***Design Review Board Case #2019-0001***

***WMATA Building - Block 15 / 2395 Mill Road***

### **Block 15 – DRB Work Session**

# Block 15 – Sketch of Ideas

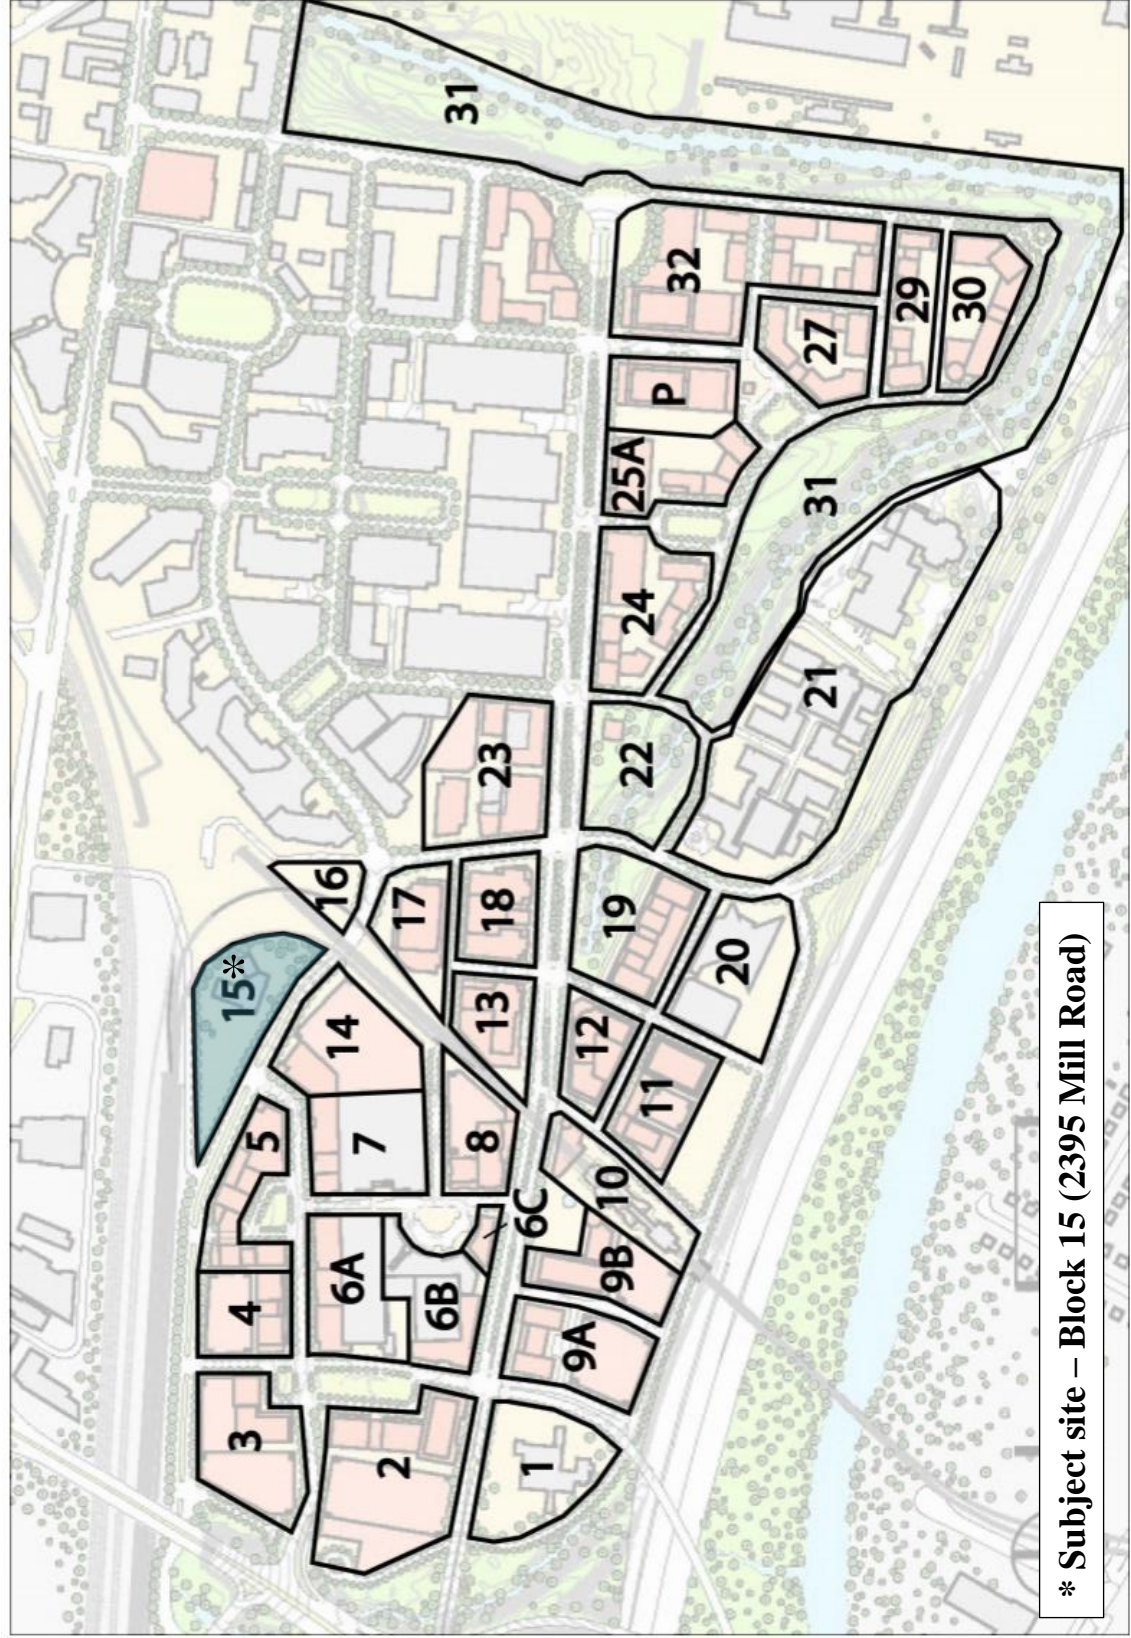
1. Elimination of 3<sup>rd</sup> (westernmost) curb cut.
2. Reduction in size of visitor lot, along with pavers and considerably increased landscaping.
3. Combination of lobby, visitor and main parking access at end of Mandeville Lane.
4. Suggestion to provide agreement for shared [service] access to future EE 15B site.
